FISH PASSAGE CENTER

MEMORANDUM

SUBJECT: Review Comments, 2013 Draft FCRPS Supplemental Biological Opinion

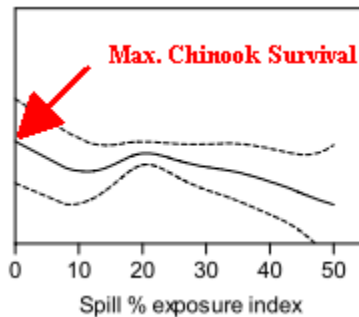
- Skalski et al. (2013) makes the comment that yearling Chinook have a maximum juvenile survival when spill is 20%, yet the model used for this same analysis predicts a maximum Chinook survival at 0% percent spill, which is obviously incorrect.

Skalski et al. (2013) references Williams et al. (2005) to note that, "For yearling Chinook salmon, survival reached a maximum at 20.6% spill." The general additive model (GAM) that Skalski et al. (2013) refers to also predicts a maximum Chinook survival when spill is zero (Figure 5). Many lines of evidence based on empirical data show that zero spill is detrimental for juvenile survival and in fact we are not aware of any other analysis available that would show that the highest possible survival would occur under zero spill operations.
